MFN 11-215

SUBJECT: Submittal of Accepted Version of GEH Quality Assurance Topical Report NEDO-11209-A, "GE Hitachi Nuclear Energy Quality Assurance Program Description," Revision 9, August 2011

REFERENCE: 1. MFN 11-212, Letter from U.S. Nuclear Regulatory Commission to Mr. Jerald G. Head, "*Final Safety Evaluation for GE Hitachi Nuclear Energy Americas Topical Report NEDO-11209, Revision 9, 'GE Hitachi Nuclear Energy Quality Assurance Program Description' (TAC No.ME4483),*" August 8, 2011

NEDO-11209-A

FIGURE 1 – ORGANIZATIONAL STRUCTURE

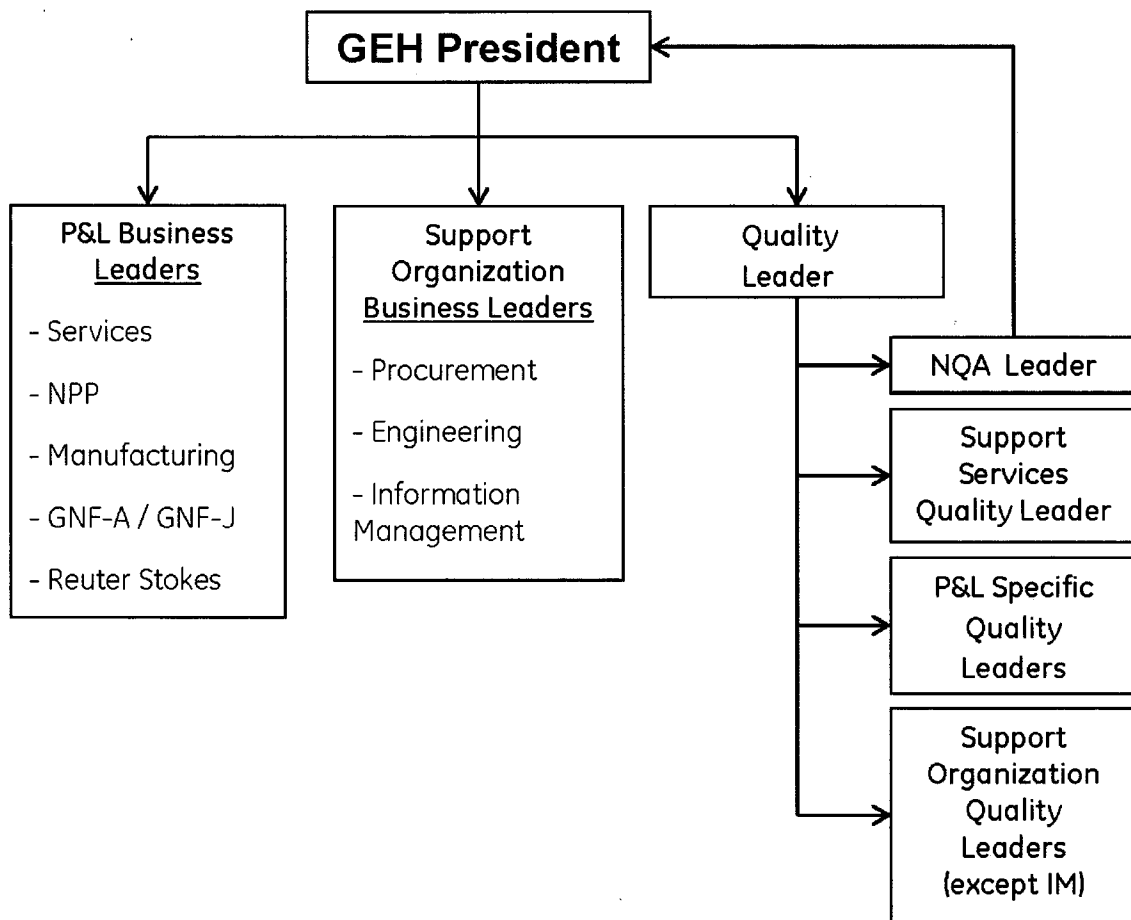
RESPONSE	NEDO 11209, Sec. 1 was revised to be more detailed and consistent with its use of terminology.
RAI - 3	SRP Section 17.5, Paragraph II.A.5.c, states in part that managers responsible for carrying out the audit functions are to report at a management level sufficiently high to ensure that cost and schedule considerations do not unduly influence decision making. NEDO-11209, Revision 9, Paragraph 1.2.2.3.1, states that the Nuclear Quality Assurance (NQA) Manager has a direct line of communication to the President to discuss quality-related issues. The NQA Manager is not represented nor is the direct line of communication reflected in Figure 1, "Organizational Structure."
	Please provide clarification in Figure1 of the location of the NQA Manager and the direct line of communication.

RESPONSE	Figure 1 was revised to show the direct line of communication between the NQA Leader and the CEO.
RAI - 4	SRP Section 17.5, Paragraph II.A.5.c, states in part that managers responsible for carrying out the audit functions are to report at a management level sufficiently high to ensure that cost and schedule considerations do not unduly influence decision making. NEDO-11209, Revision 9, Paragraph 1.2.2.3.4 states in part that the structure is designed to provide sufficient independence for the "Specific Quality Leaders" from cost and schedule when opposed to quality and safety considerations, provides the required independence between the performers and the verifiers, and enables a direct line of communication to top management.
	Please provide clarification of the term "top management."
	Please provide clarification in Figure 1 of the location of the "Specific Quality Leaders" and the direct line of communication described in Paragraph 1.2.2.3.4 of NEDO-11209, Revision 9.
